INDESIT company

LFF8214XEU/HA.R

F065255

2270140 Exploded views

n4513g02: INTRODUCTION OF NEW SYNCHRONOUS MOTOR

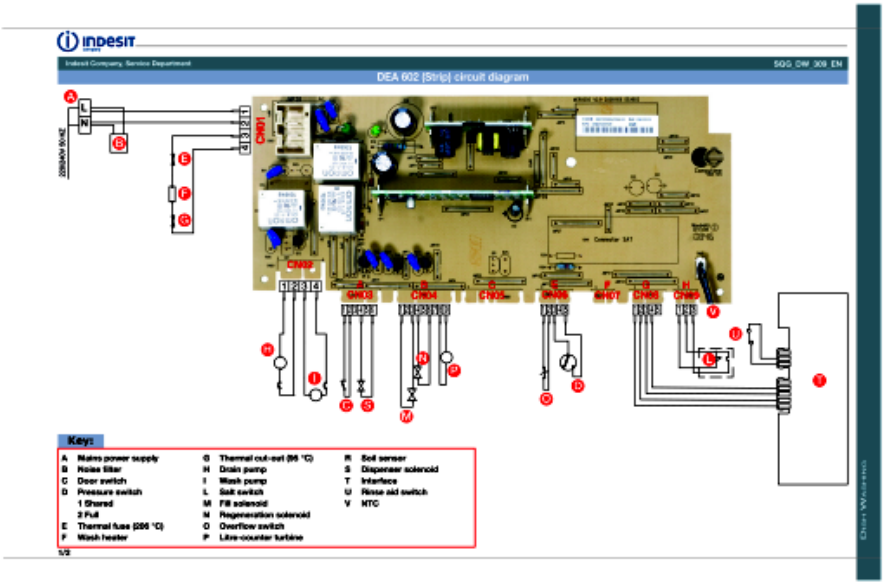
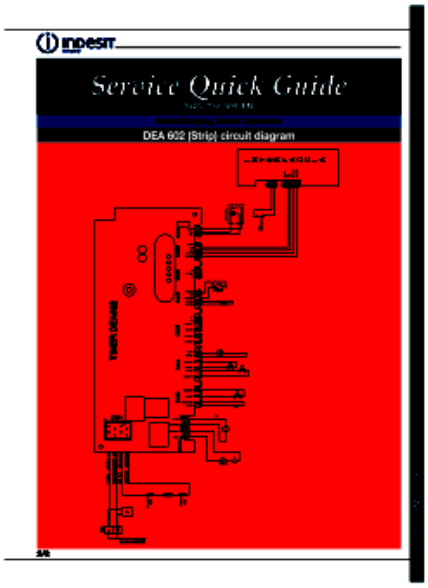
A new electropump has been introduced in the synchronous motor. This is perfectly interchangeable with the previous one, only the dowel has been modified improving its quality.

New motors have new codes:

Old New
C00256523 -> C00302800
C00256525 -> C00302798
C00272798 -> C00302796
